Visual change: Temporarily different color for connectors and accessories

1. General Overview

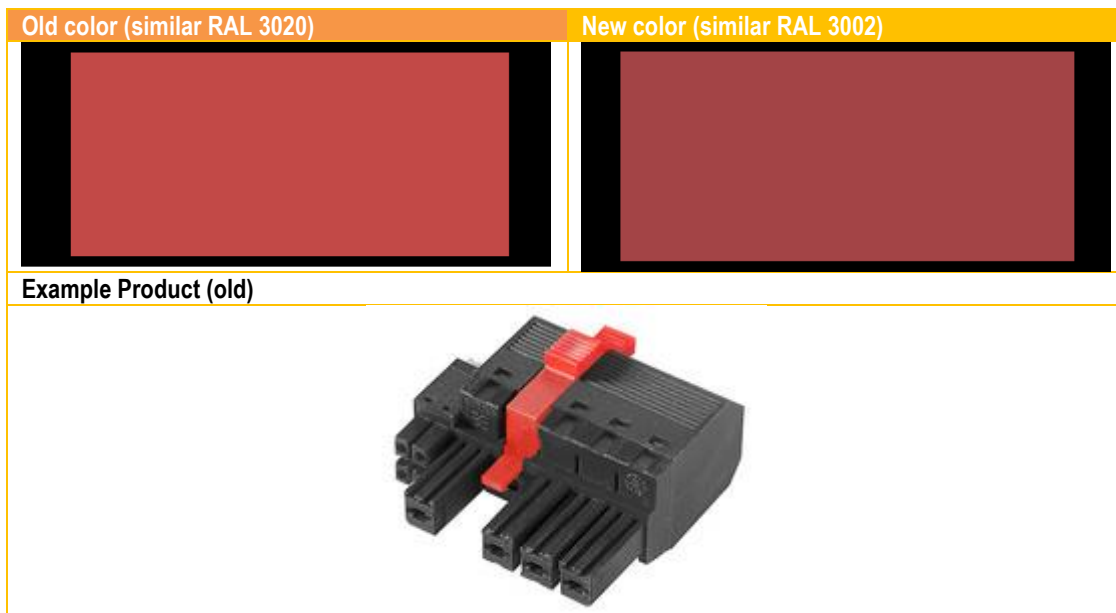
this temporary change of color serves to maintain the supply. The articles listed below will be supplied in a different shade of red. Please pass on this product information to your staff and, if applicable, to your customers.

Due to a short-term delivery stop of a color pigment of our plastic granulates, we temporarily have to switch red connectors and connector components (e.g. flange actuators, etc.) to a different color.
